### THE SERVICED GRID CODE – ISSUE 3 REVISION 35

Revision 35 of Issue 3 of the Grid Code has been approved by the Authority for implementation on **1<sup>st</sup> May 2009**.

## THE GRID CODE – ISSUE 3 REVISION 35

- **A/09** – Grid Code Requirements for Synchronous Generating Units Exceeding Rated MW

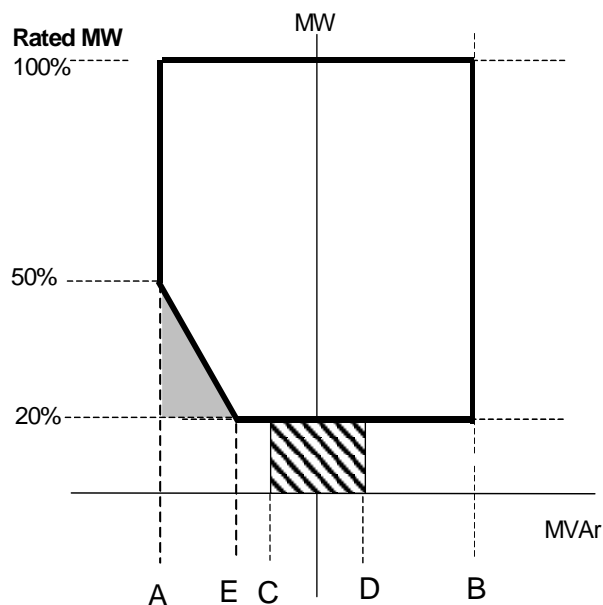
CC.6.3.2 (a) When supplying **Rated MW**, all **Synchronous Generating Units** must be capable of continuous operation at any point between the limits 0.85 **Power Factor** lagging and 0.95 **Power Factor** leading at the **Synchronous Generating Unit** terminals. At **Active Power** output levels other than **Rated MW**, all **Synchronous Generating Units** must be capable of continuous operation at any point between the **Reactive Power** capability limits identified on the **Generator Performance Chart**.

In addition to the above paragraph, where **Synchronous Generating Unit(s)**

- (i) have a **CEC** which has been increased above **Rated MW** (or the **CEC** of the **CCGT Module** has increased above the sum of **Rated MW** of the **Generating Units** comprising the **CCGT Module**), and such increase takes effect on or after 1<sup>st</sup> May 2009, or have a **Completion Date** on or after 1<sup>st</sup> May 2009, the minimum lagging **Reactive Power** capability at the terminals of such **Synchronous Generating Unit(s)** must be 0.9 **Power Factor** at all **Active Power** output levels in excess of **Rated MW**. Further, the **User** shall comply with the provisions of and any instructions given pursuant to BC1.8 and the relevant **Bilateral Agreement**; or

- For new connections, and for existing power stations that request a formal increase in their CEC, above Rated MW, the Grid Code will specify the following additional technical requirements (*Applicable from 1<sup>st</sup> May 2009*):

- the Generating Unit must be capable of continuous operation at least 0.9 p.f. lagging;
  - the leading power factor capability will be based on the under excitation limiter characteristic;
